**Rancho Las Virgenes
Regional Facilities Expansion IV**

Solids Handling and Composting Facilities

LAS VIRGENES MWD / TRIUNFO CSD
RANCHO LAS VIRGENES - REGIONAL FACILITIES EXPANSION IV
SOLIDS HANDLING AND COMPOSTING FACILITIES

ANAEROBIC DIGESTERS AND
 DIGESTER PUMP STATION

SHEET **IM-2** OF 508 SHEETS

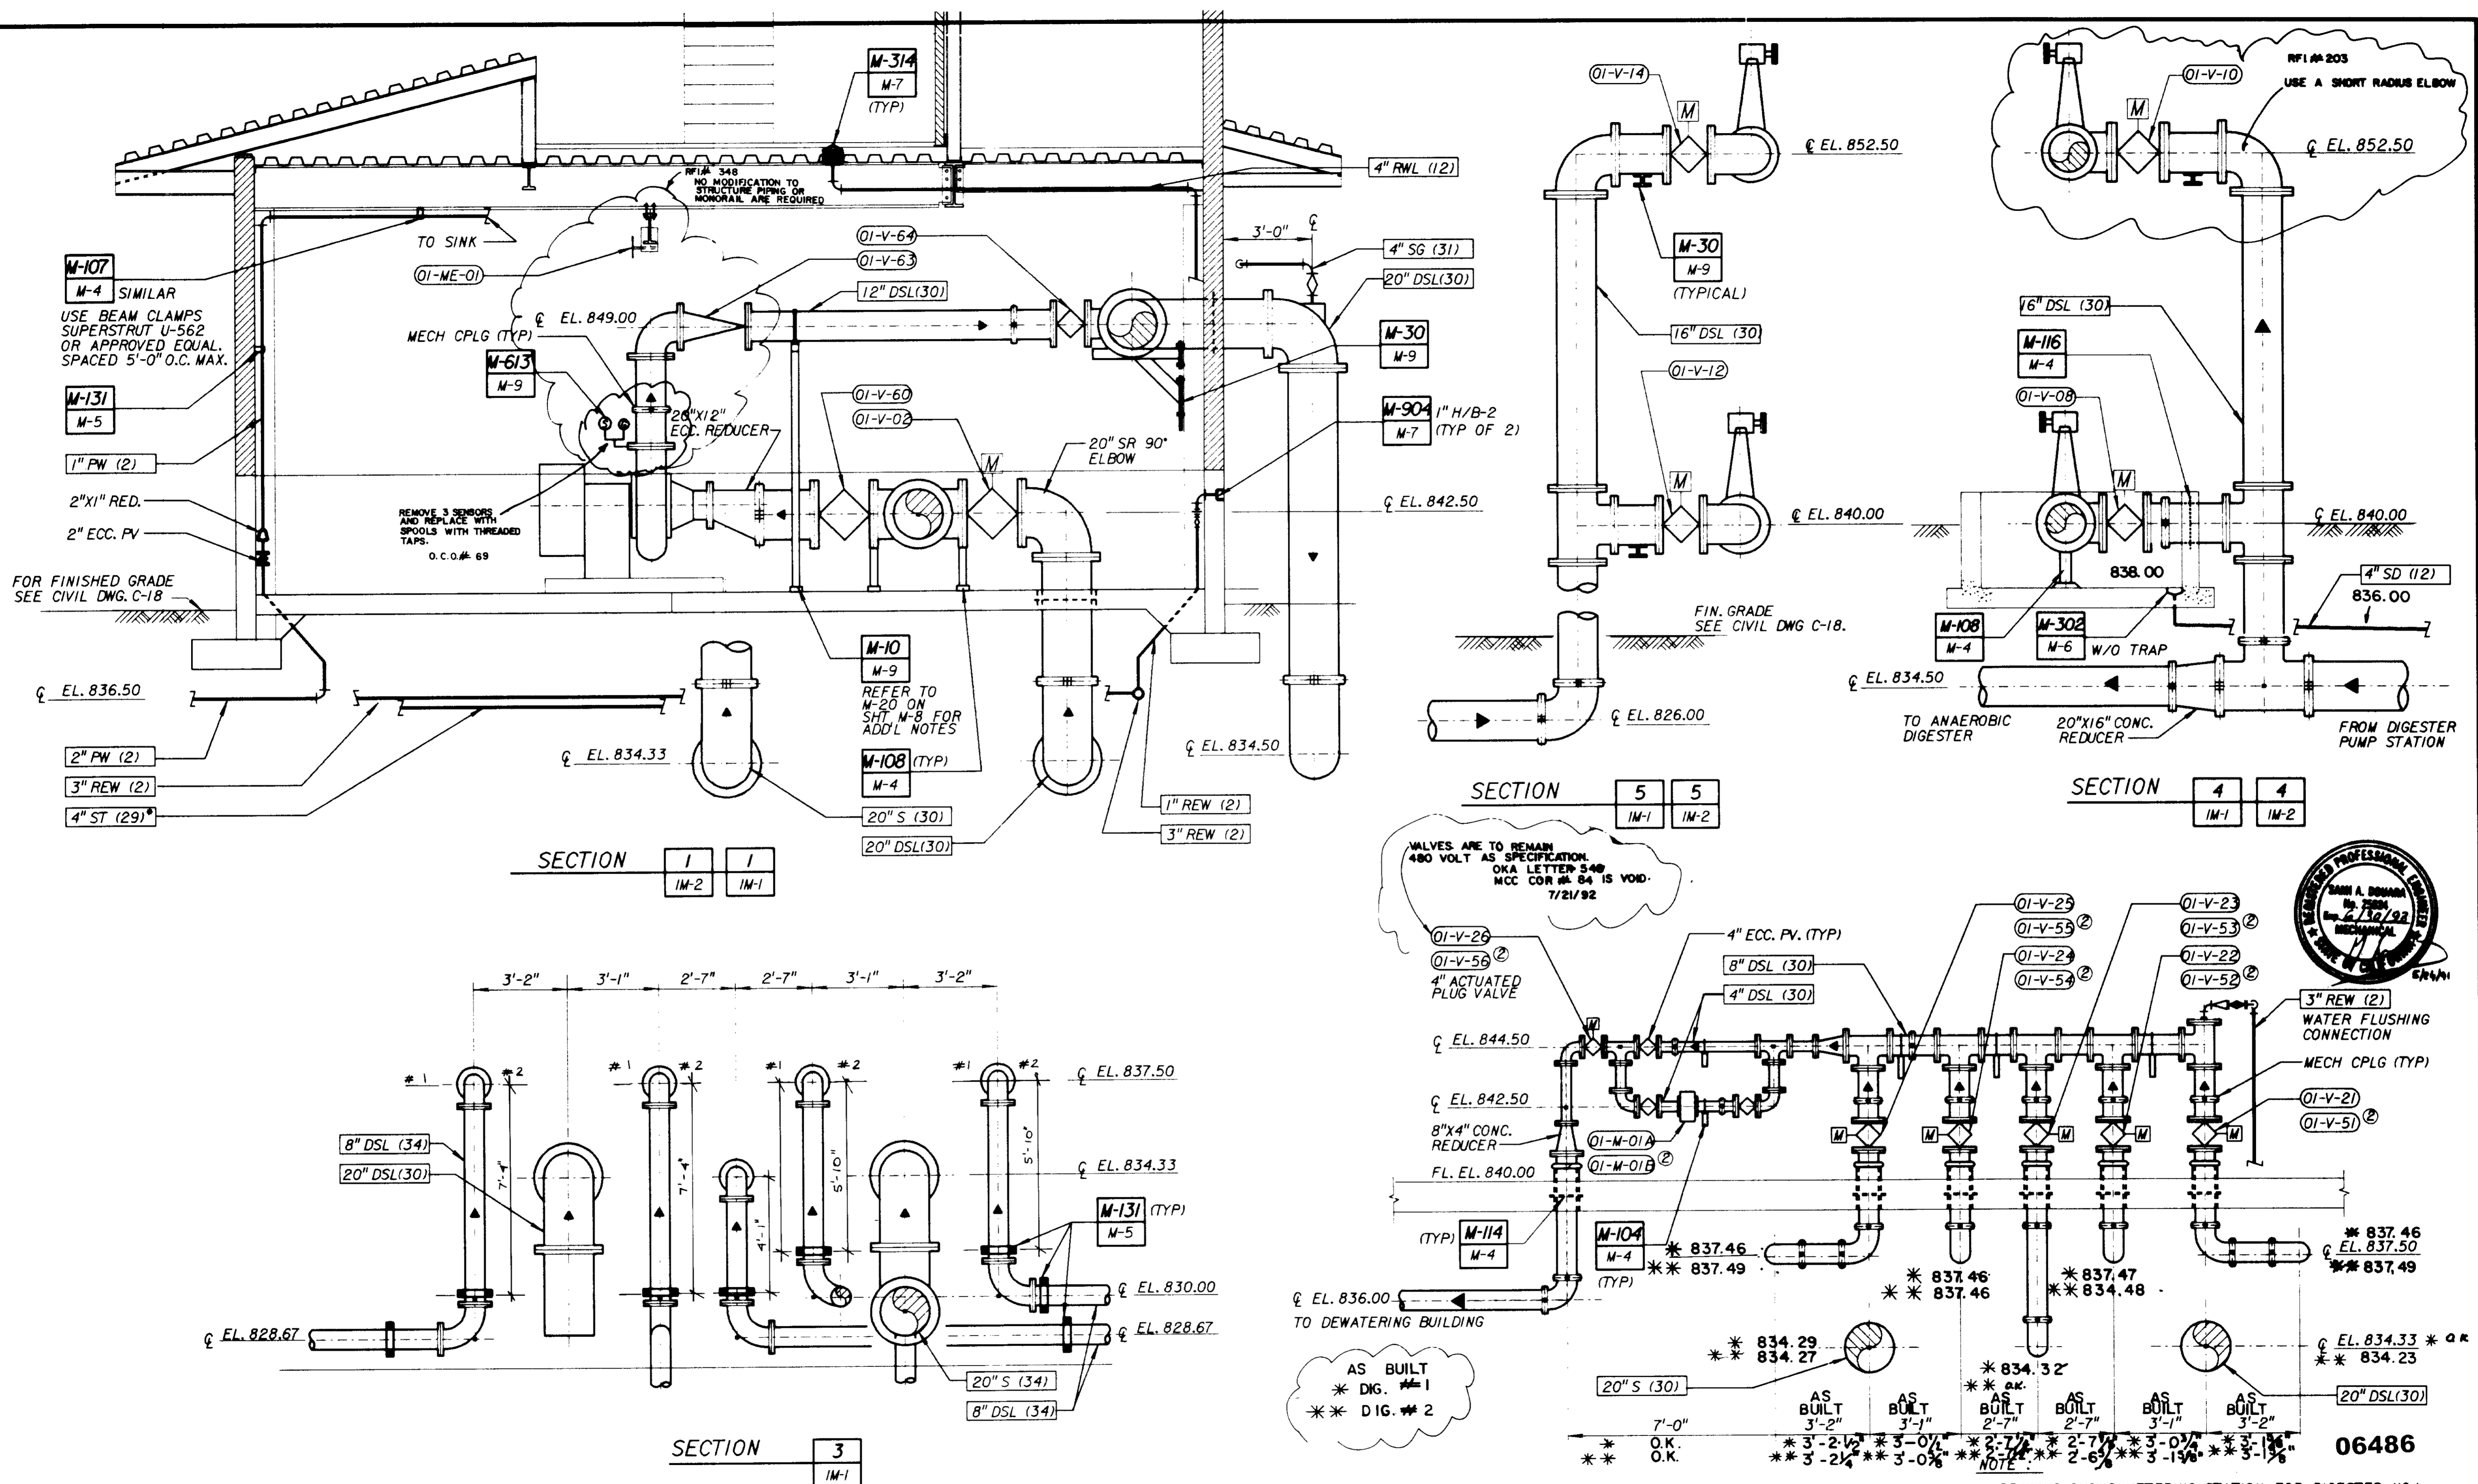
THROUGH CONDUITS IC-08 AND IC-16 RESPECTIVELY. THE SIGNAL SHOULD BE TRANSMITTED THROUGH LCB 100 TO PCM 100 AND THE DCS SYSTEM. A HIGH PRESSURE EVENT SHOULD ALARM SEPARATELY FOR EACH DIGESTER AT THE HIGHEST PRIORITY LEVEL. RANGE APPROPRIATE FOR DIGESTERS IS 0-20' W.C.

REPLACE THE THREE DIRECT- DRIVE MOTORS WITH SIDE-MOUNT MOTORS & REVISE MOTOR FREQUENCY FROM 1200 RPM TO 1800 RPM.
RFI # 302
COR # 33
O.C.O.#-14

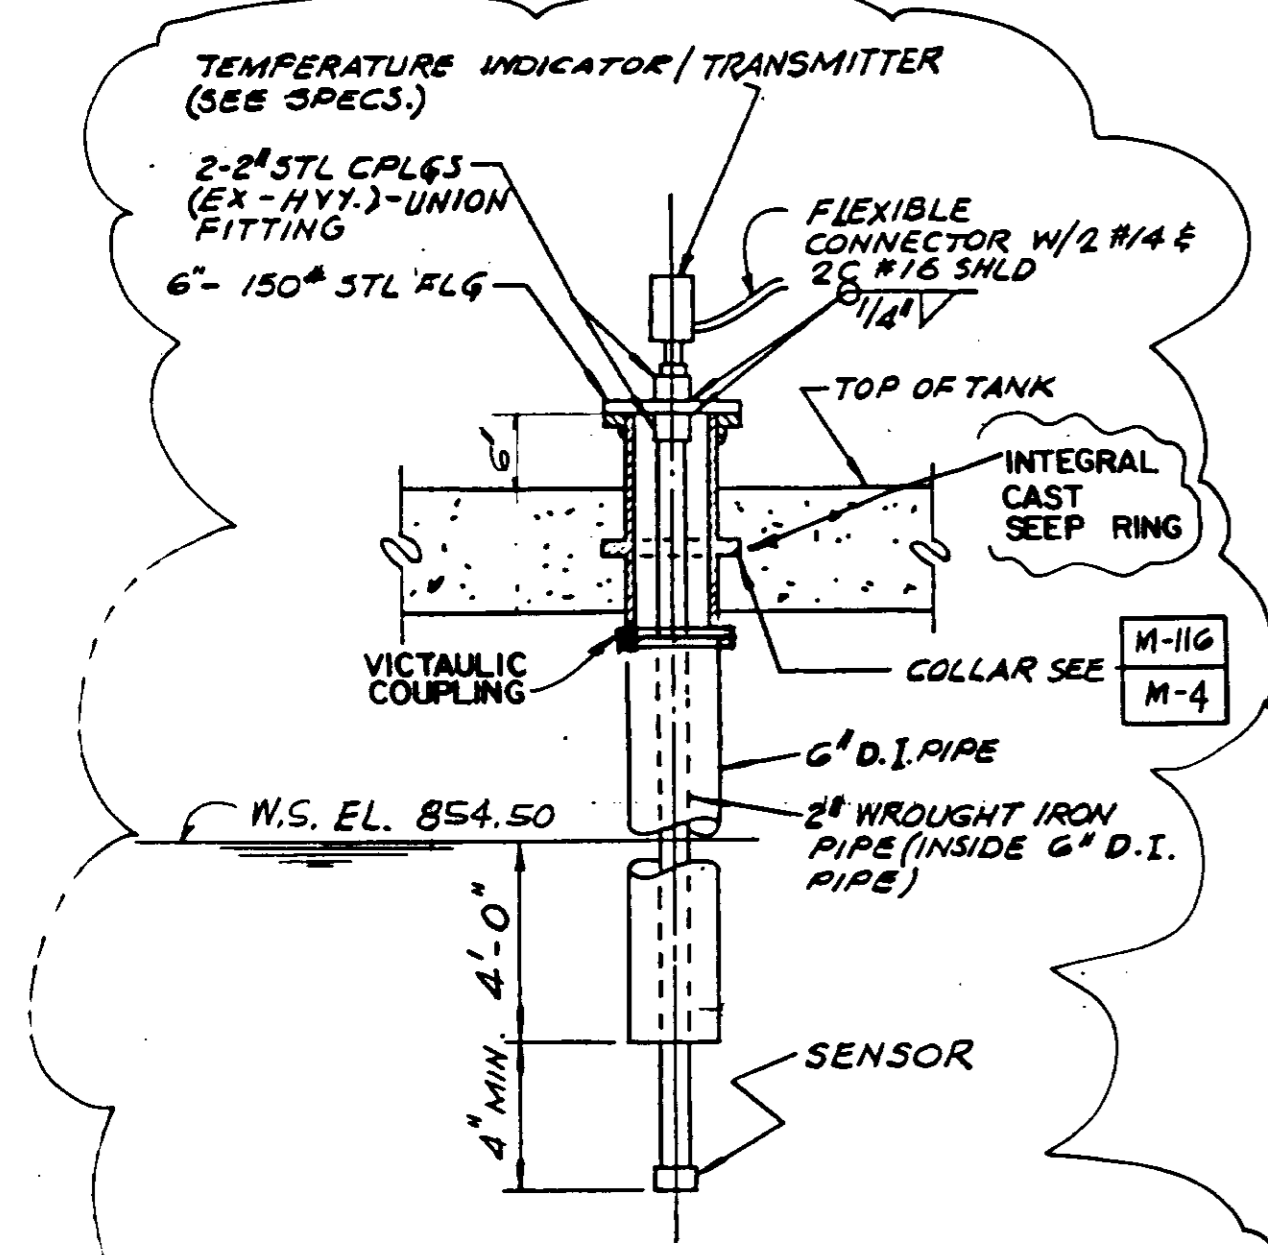
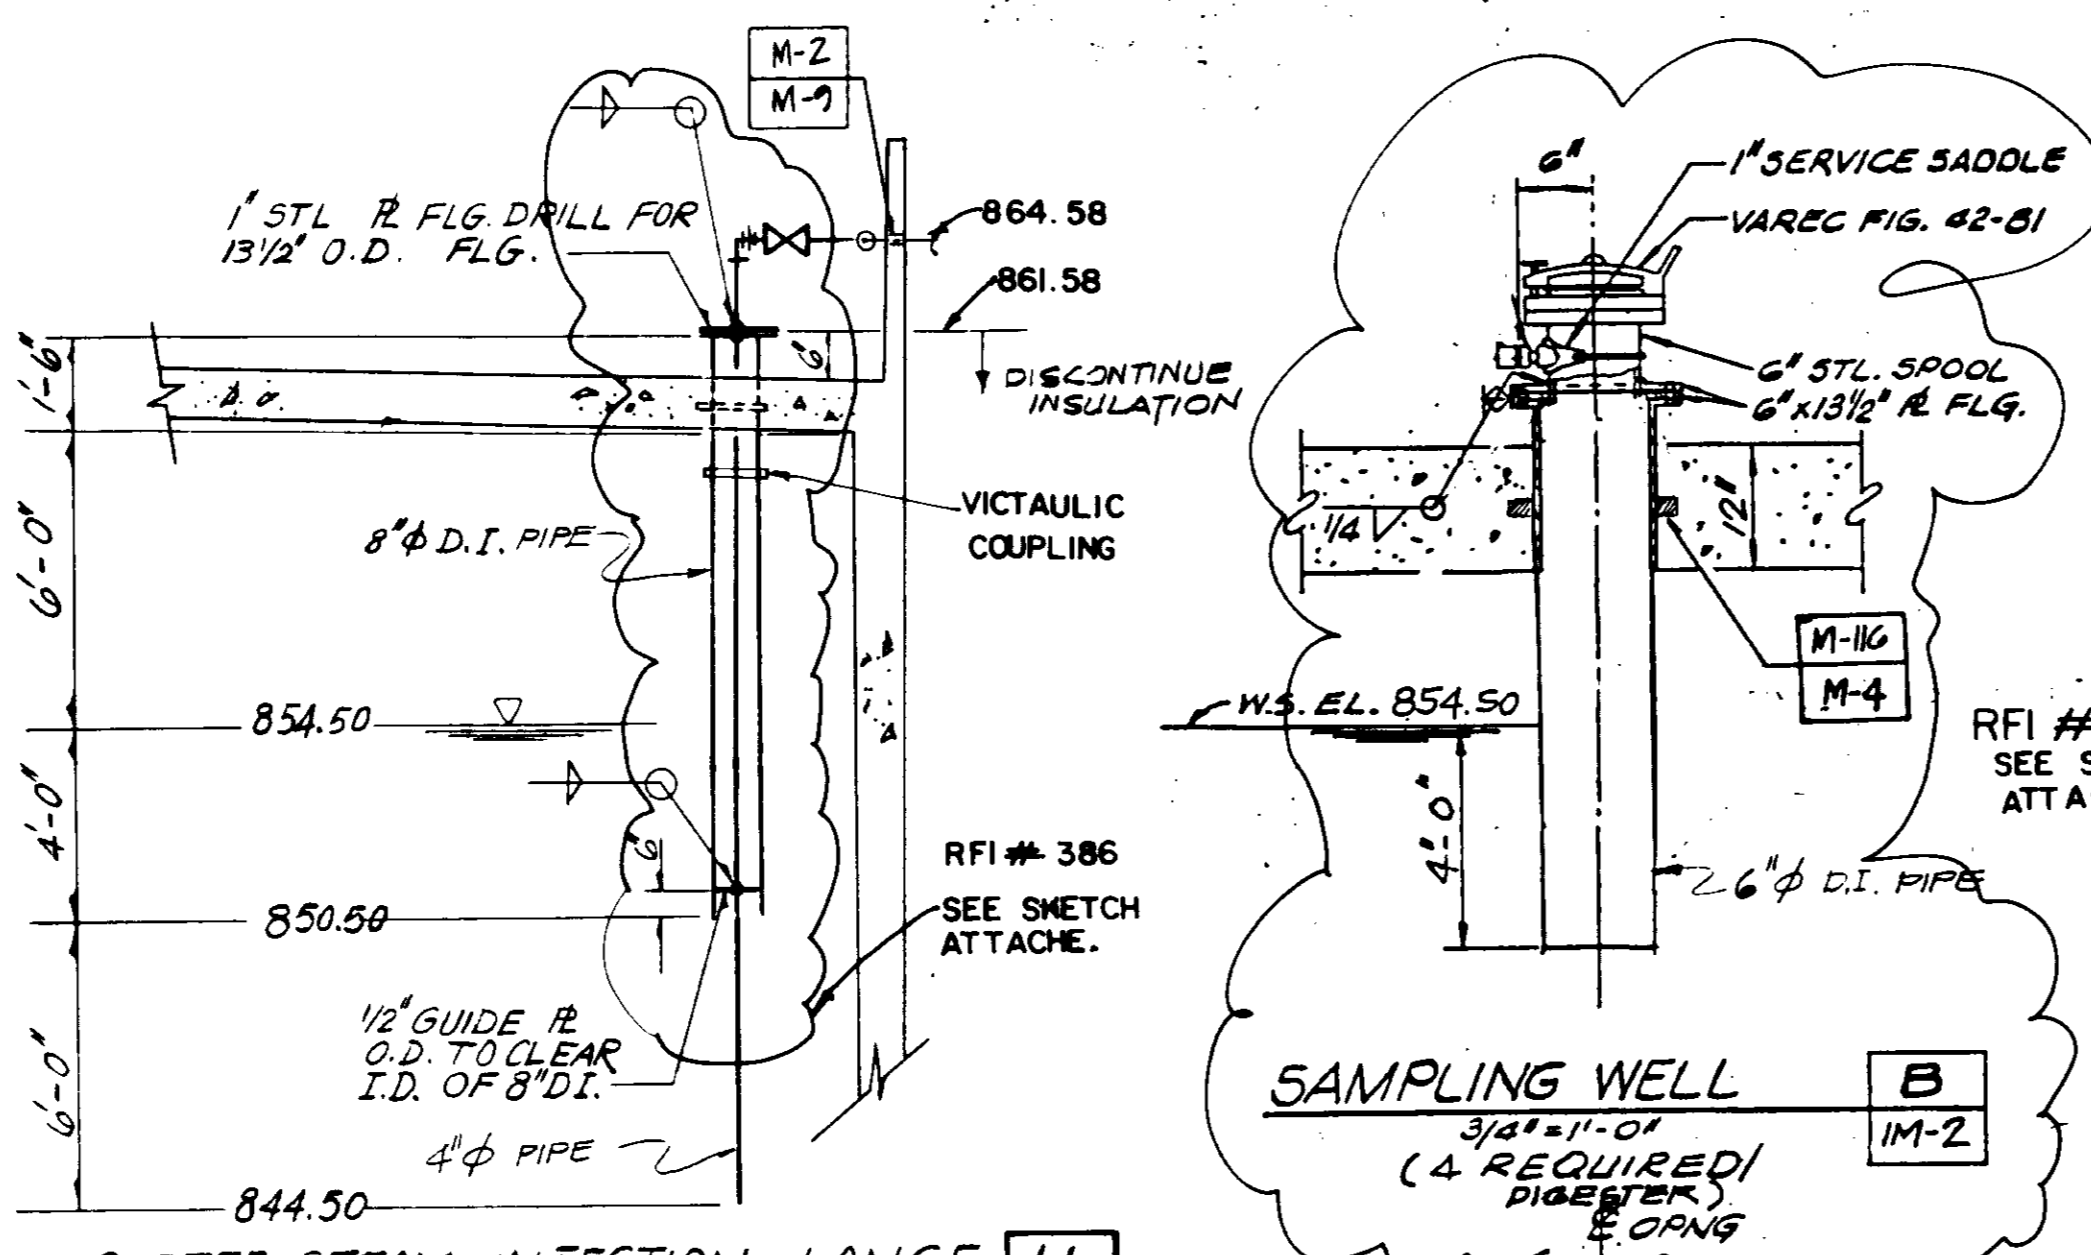
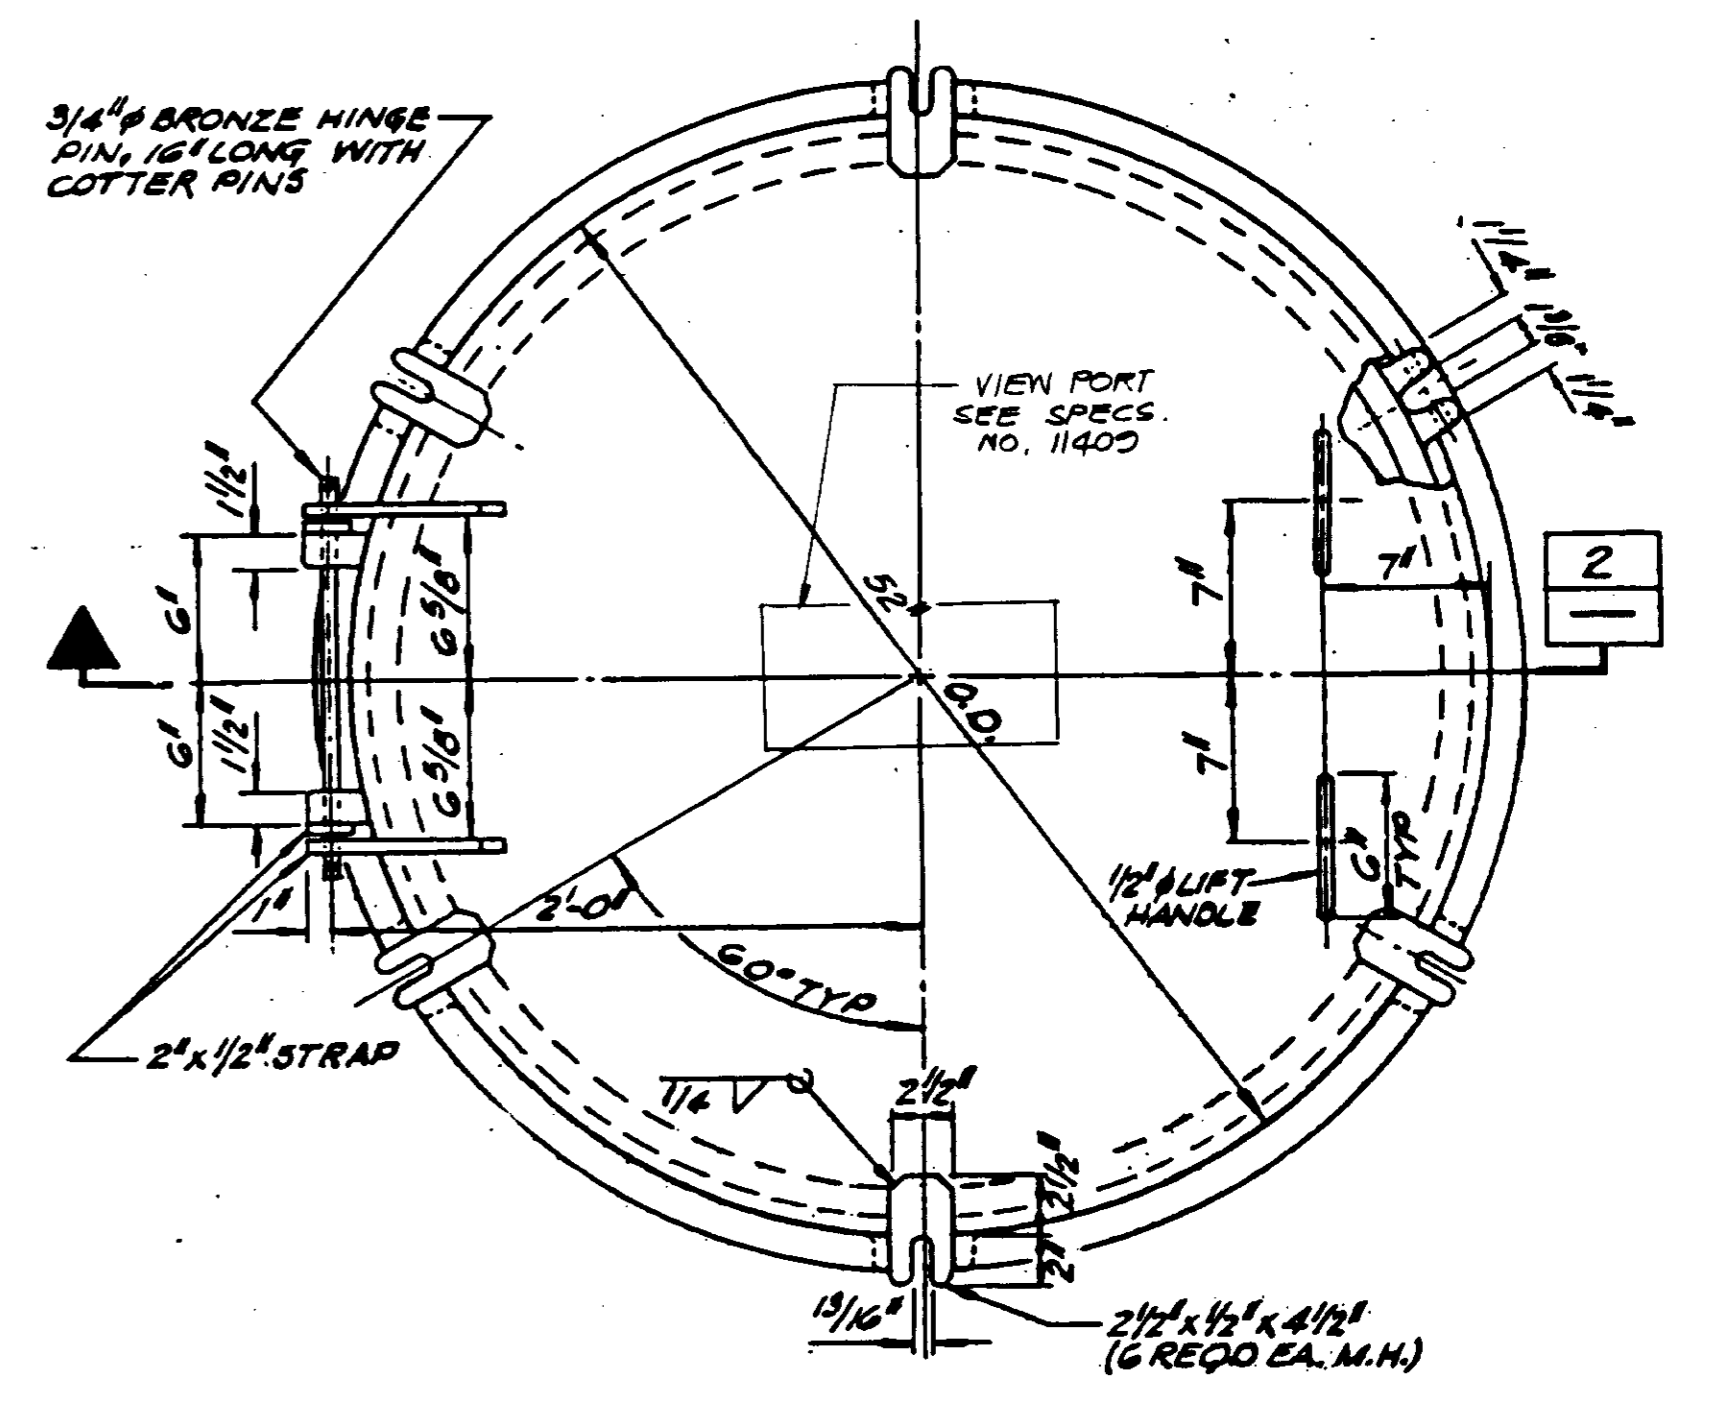
R.F.I. # 360
 R.F.I. # 38
 FOR LONG ROOF PENETRATIONS

R.F.I. # 386
 SEE SCETCH
 ATTACHED
